1 July 2025

Our Ref: 240065-M
Reissue of: 240065-J

Geotechnical Response to Council Queries Delmore Residential Development

Response (11)21

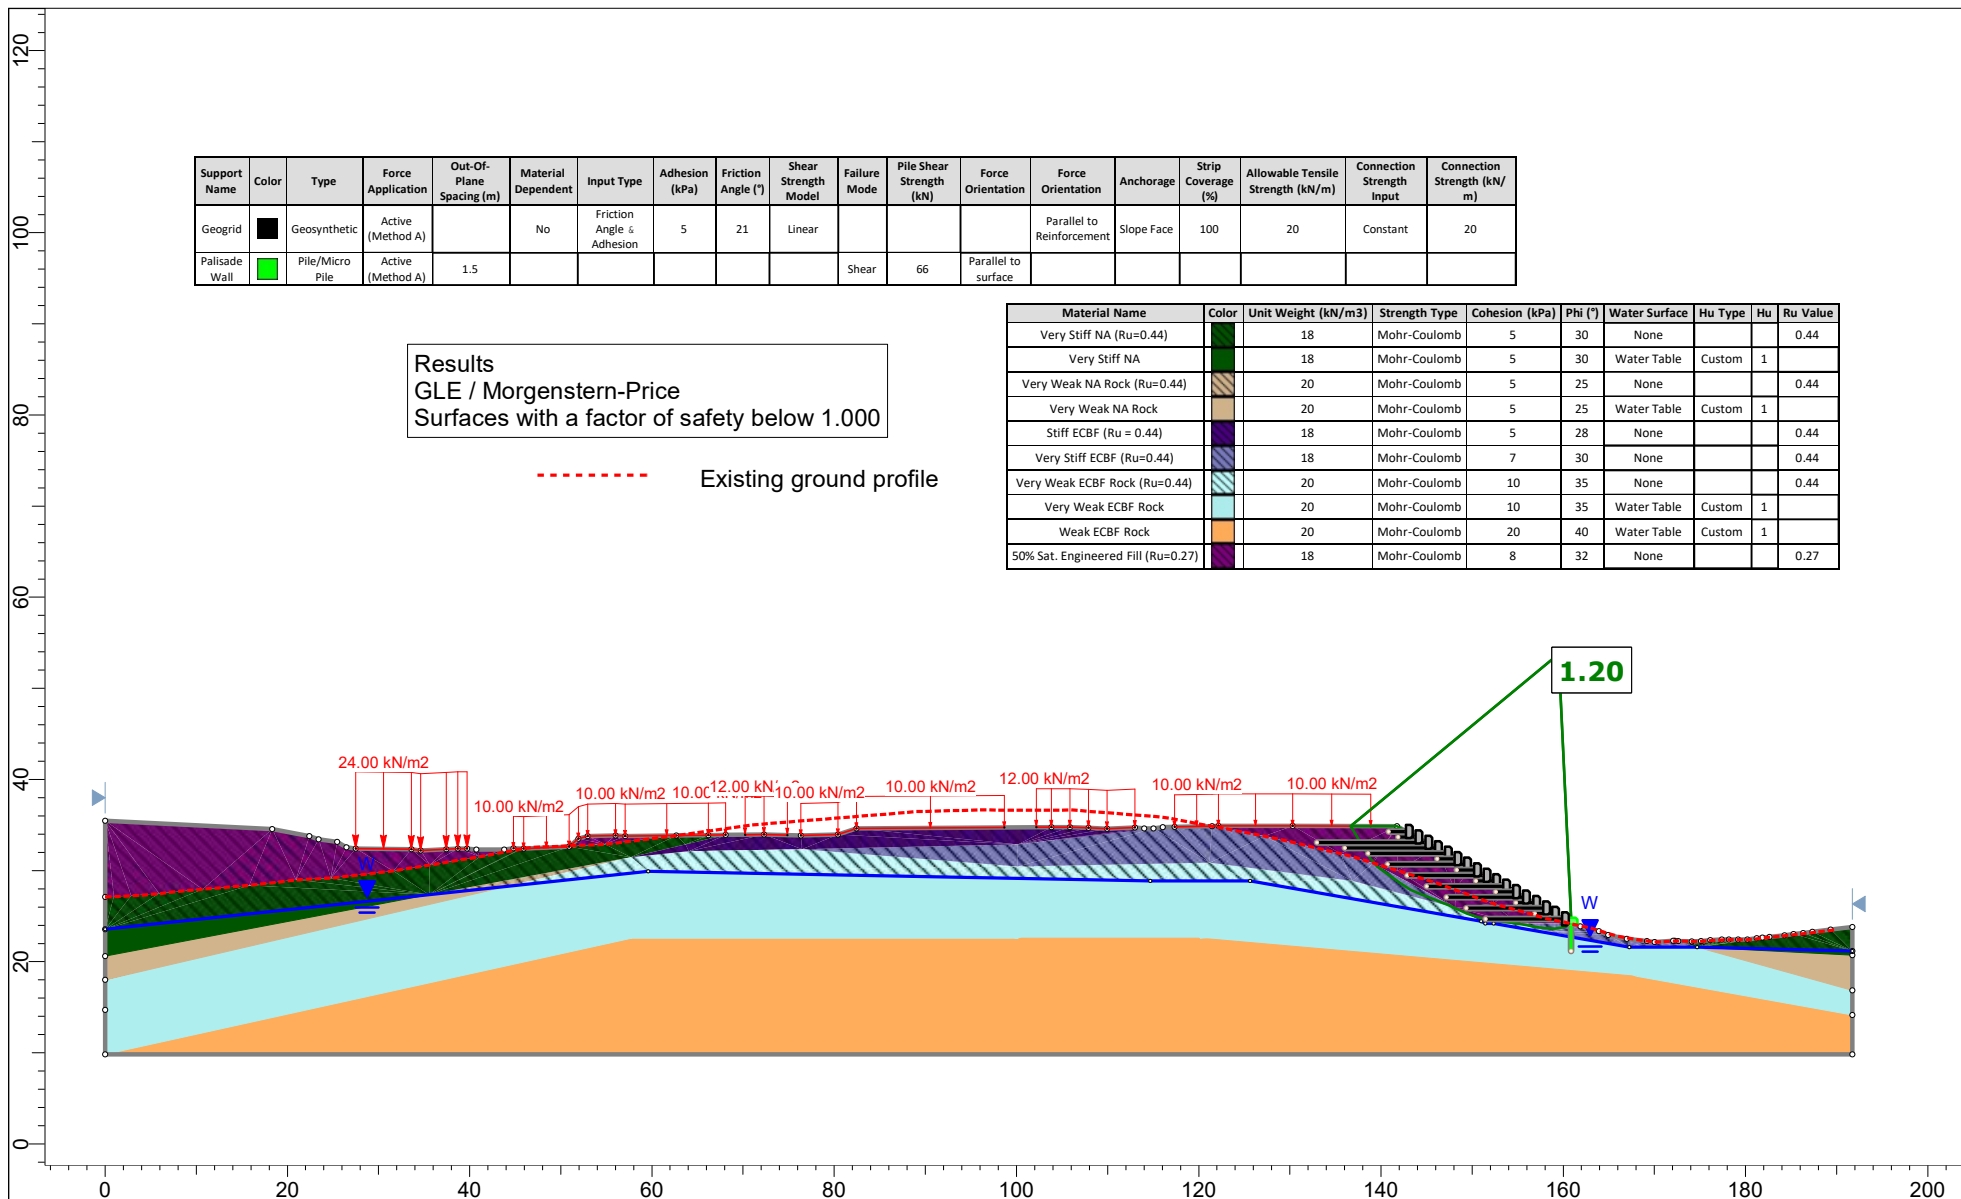
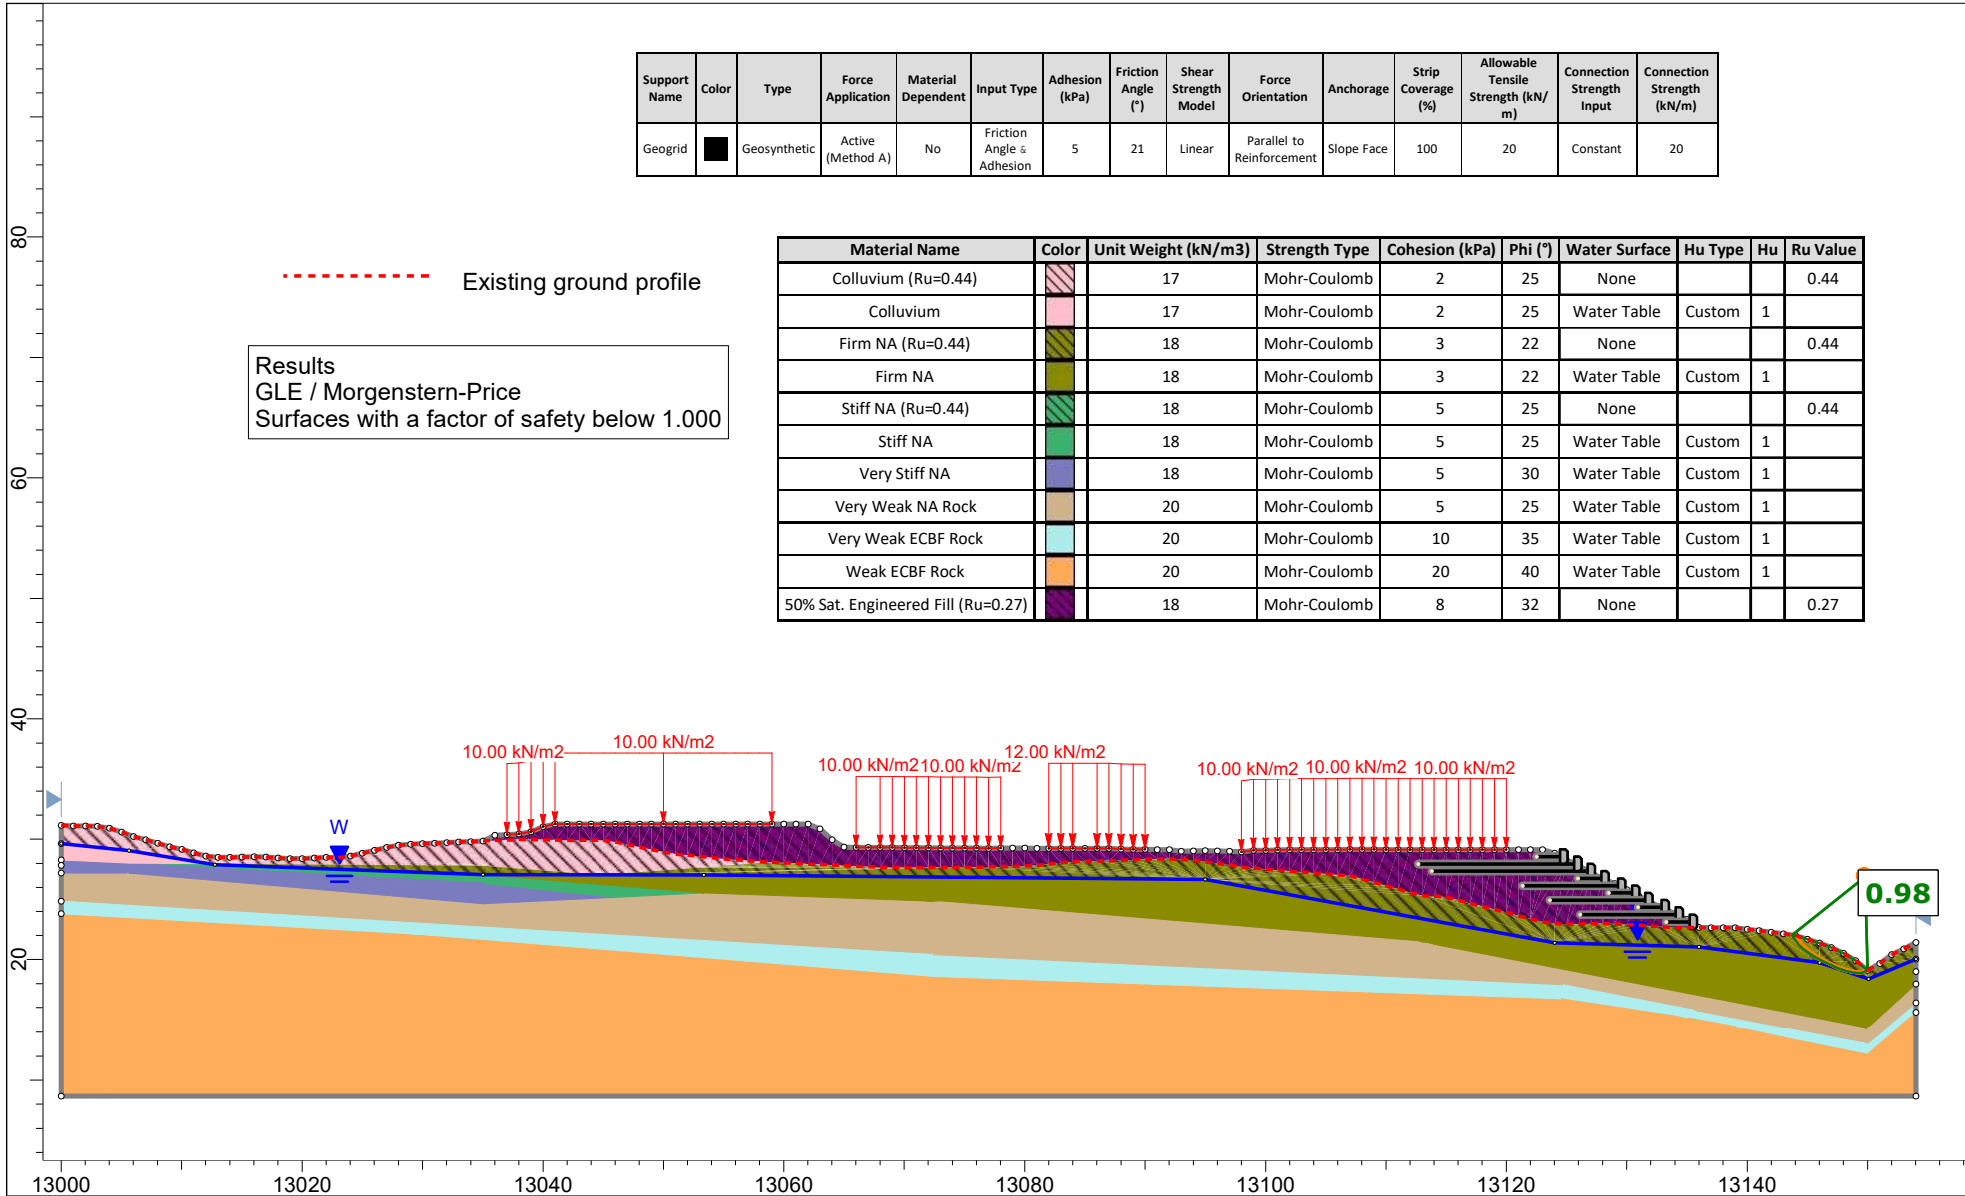
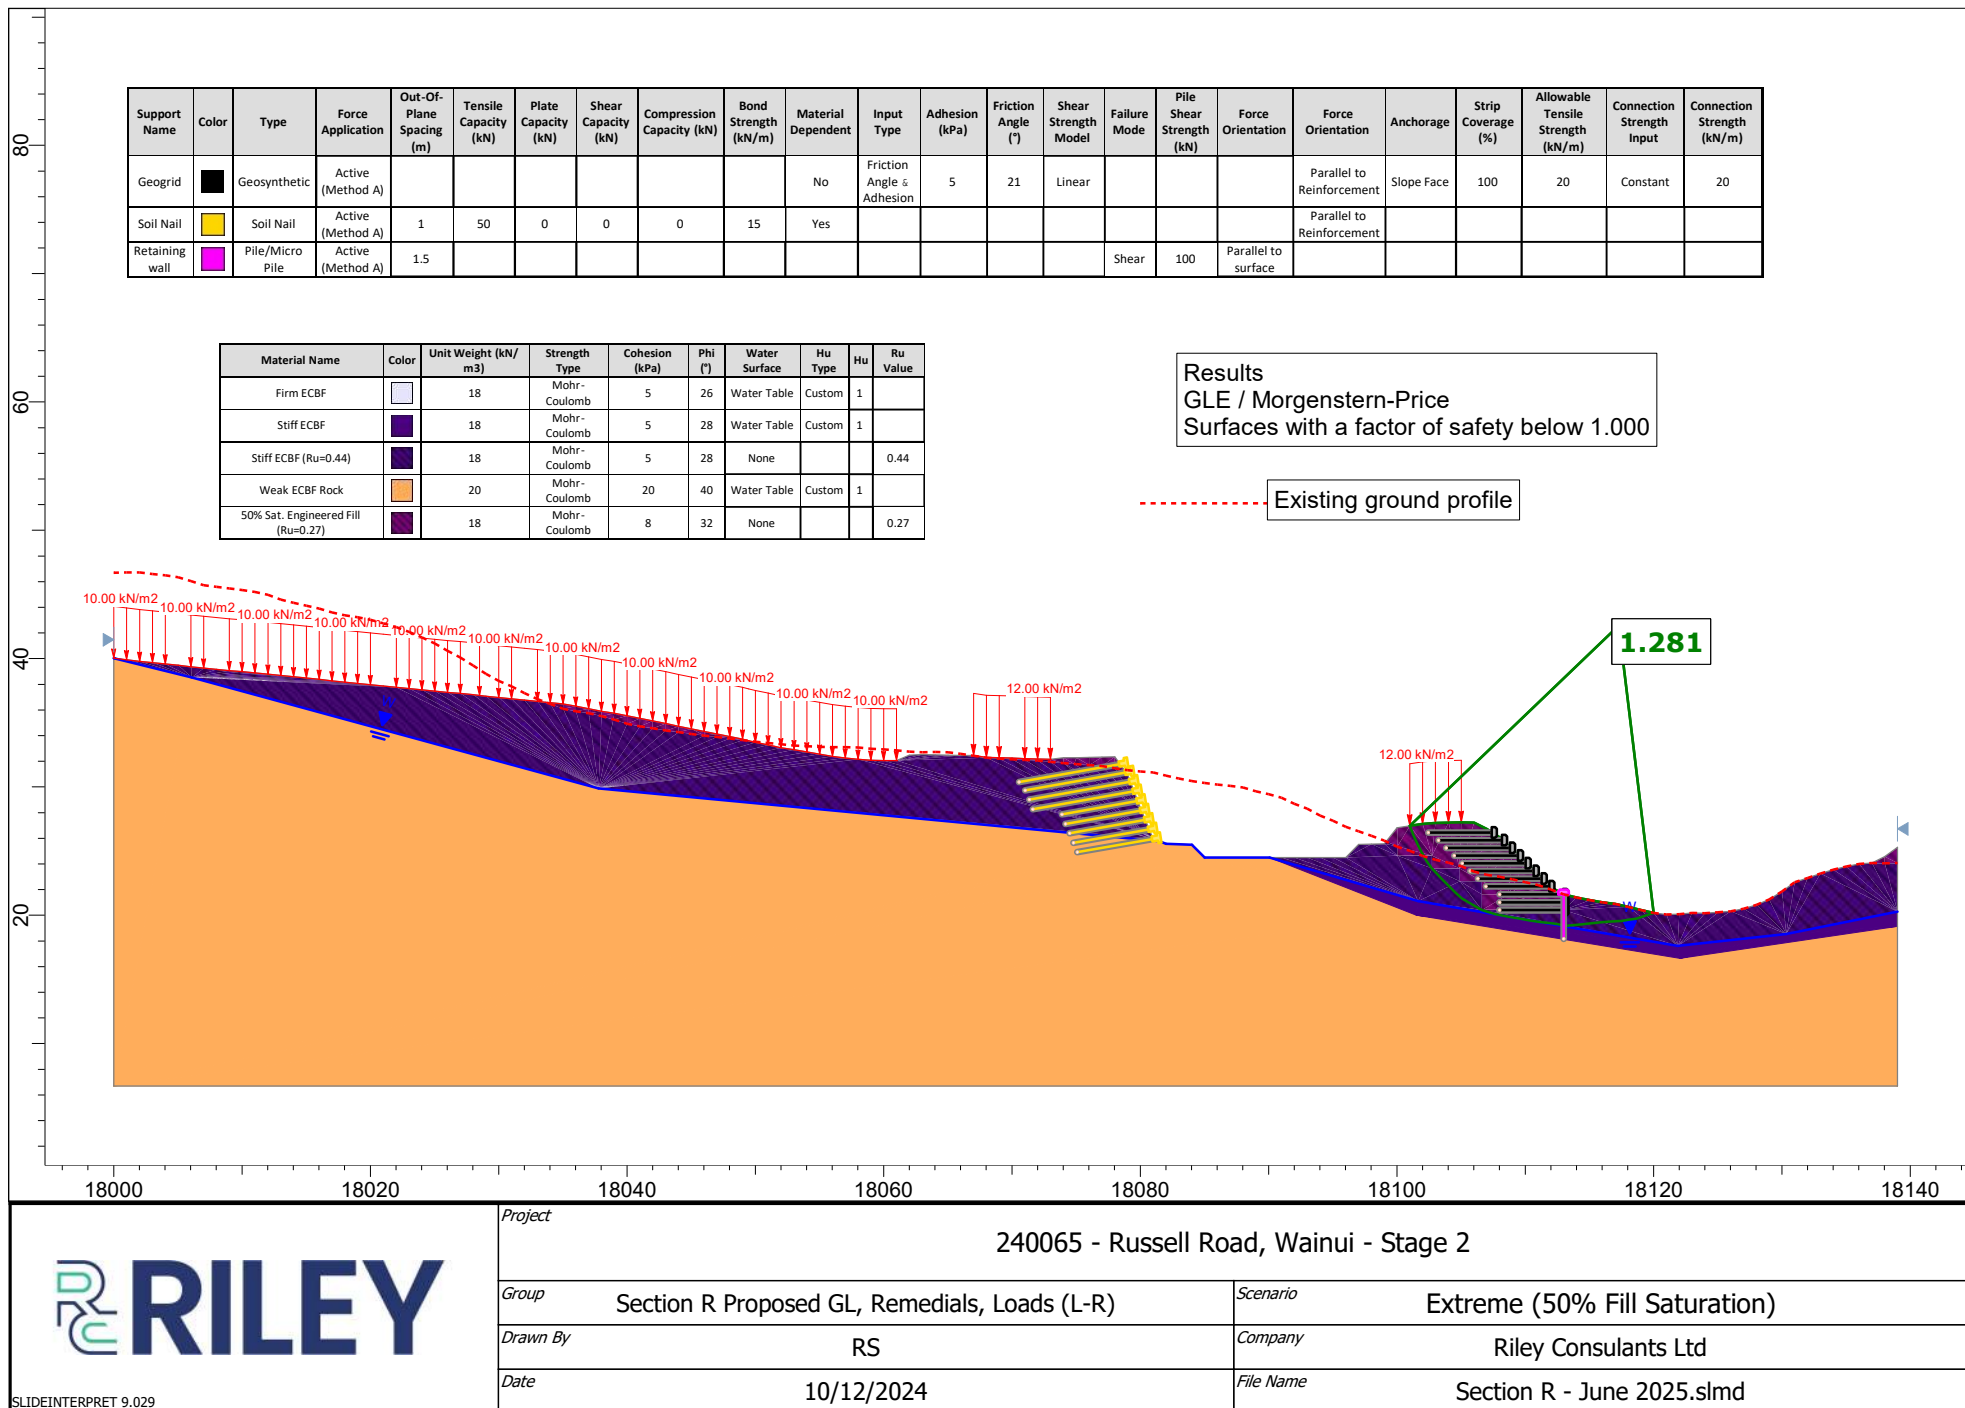
The stability analysis assumes that the fill material is completely dry. However, porewater pressure could potentially develop within the fill, particularly in the event of drainage system failure. Therefore, the potential effects of porewater pressure should be considered in the stability analysis to ensure a more conservative and realistic assessment.

However, as agreed with the Auckland Council Geotechnical Specialist, Riley has reanalysed the slope stability of a selection of eight cross sections to also include 50% saturation of the engineered fill as part of the extreme groundwater scenario (in addition to the post-development surcharges included in our response to Query 19 above). Riley and the Council Specialist agreed that a target FoS of 1.0 would appropriate given that it would take a very extreme rainfall event to result in the fill becoming saturated to this degree. An equivalent Ru value of 0.27 was adopted in the SLIDE2 models to simulate 50% soil saturation. All eight sections analysed under these conditions returned FoS values greater than 1 within the development area, indicating that slope instability is unlikely in this scenario. Some of the models returned minimum FoS values less than 1.0, however, these failure planes are all located on natural slopes remote from the development area and any stability enhancement features, i.e. the FoS in these areas is not reduced from pre-development FoS for this scenario. Slope stability outputs are appended to this letter.

The analysis undertaken to address this query, assumes that the subsoil drains have become ineffective (e.g. blocked or impaired function). The subsoil drainage to be installed as part of the development will utilise TNZ F/2 compliant drainage material. In Riley's experience, this grade of drainage material adequately mitigates the risk of subsoil drainage becoming blocked or needing long-term maintenance. For this reason, Riley considers that the proposed subsoil drainage should not require an Operation and Maintenance Plan during the design life of the drains.
